Response to Objection to Outline planning permission for Extension of MIRA Technology Park

Technical Note

Document Reference: EED13833-118-TN-6-1-1

PROPOSAL: Outline planning permission for Extension of MIRA Technology Park to comprise employment use (Class B2); associated office and service uses (Class Eg); storage (Class B8); new spine road; car parking, landscaping and enabling works - All matters reserved

Figure 1 Extract of the Drawing Number 13833-WIE-ZZ-XX-DR-92004 Revision P05

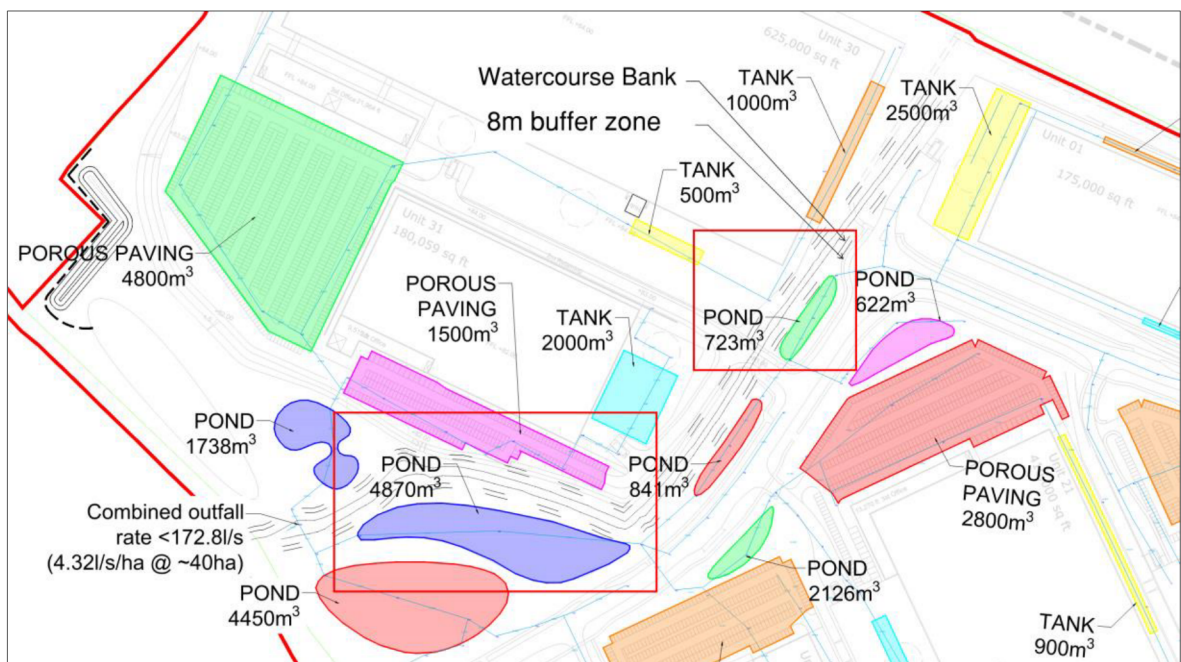
The previously submitted technical note (EED13833-118-TN-3-1-3) stated in paragraph 1.16 that two of the previously proposed ponds would not provide the full 8m easement from the watercourse on site, and therefore the drainage strategy would be revised to provide swales instead. The technical note recently submitted (EED13833-118-TN-5-1-2) does not reflect these changes and the drainage strategy remains unchanged. The LLFA therefore maintains their request for further details of a revised drainage strategy that honours the 8m easement and performs effectively. The LLFA requests:

1. The previously submitted technical note (EED13833-118-TN-3-1-3) stated in paragraph 1.16 that two of the previously proposed ponds would not provide the full 8m easement from the watercourse on site, and therefore the drainage strategy would be revised to provide swales instead. The technical note recently submitted (EED13833-118-TN-5-1-2) does not reflect these changes and the drainage strategy remains unchanged. The LLFA therefore maintains their request for further details of a revised drainage strategy that honours the 8m easement and performs effectively. The LLFA requests:

- 1.3. As part of the revised drainage strategy EED13833-118-TN-5-1-2, the two ponds were realigned to fall outside the 8m buffer zone (easement) instead of replacing them as swales. The reason for doing this is that the buffer required for the two ponds was not far off from the requirement of 8m easement. Swales shall be investigated as a proposal as part of the detailed scheme design if still required. As part of outline planning application, the drainage strategy demonstrates there is sufficient space allowed for storage by retaining pond solution as such without needing them to replace with swales.

- 1.4. Figure 1 below highlights the two ponds in red box that were realigned outside of the 8m easement. This is an extract of the Drawing Number 13833-WIE-ZZ-XX-DR-92004 Revision P05 from the Appendix B of EED13833-118-TN-5-1-2 submitted in support of the drainage strategy.

- 1.5. Based on the above, it is understood that the revised Indicative Surface Water Drainage Strategy and the calculations submitted as part of the technical note EED13833-118-TN-5-1-2 reflects all the changes and is sufficient to overcome the objection.
